REFERENCE:	TSB: 08-197-24 GROUP: 08 - Electrical	Date:	September 6, 2024	REVISION:	—
VEHICLES AFFECTED:	2023 (DJ) RAM 2500 Pickup This bulletin applies to vehicles equipped with a 6.4L V8 Heavy Duty Hemi MDS Engine (Sales Code ESB) or a 6.7L I6 Cummins Turbo Diesel Engine.	MARKET APPLICABILITY:			
		<input checked="" type="checkbox"/> NA <input type="checkbox"/> MEA <input type="checkbox"/> SA <input type="checkbox"/> IAP <input type="checkbox"/> EE <input type="checkbox"/> CH			
CUSTOMER SYMPTOM:	The technician or customer may experience: <ul style="list-style-type: none"> While installing the Mopar service battery as a replacement for the factory battery, there is an interference issue with the right busbar cover on the positive terminal side of the battery. 				
CAUSE:	A difference in the placement of the positive busbar terminal over the service battery

This bulletin involves modifying the right busbar cover on the positive terminal side of the battery.

Fig. 1
Right Busbar Cover

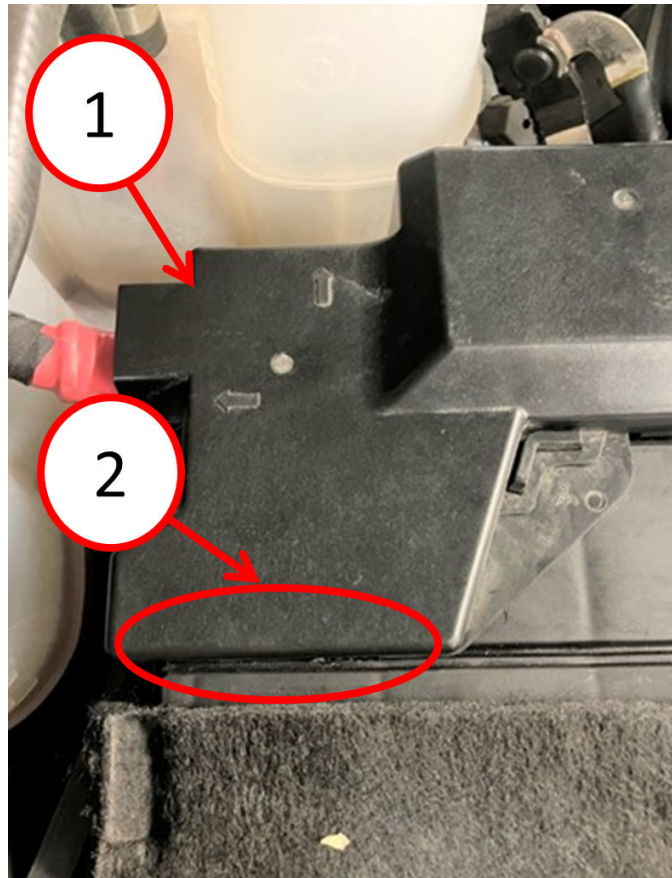
1. Remove the right busbar cover [Fig. 1](#).

1 - Busbar Cover
2 - Cover Area To Be Modified

2. Mark the cutting location starting width 16 mm (0.62 in.) from the cover edge and 54 mm (2.12 in.) wide [Fig. 1](#).
3. Using a suitable cutting tool, cut a window into the side of the busbar cover 20 mm (0.78 in.) high [Fig. 2](#) and 35 mm (1.37 in.) wide [Fig. 3](#).
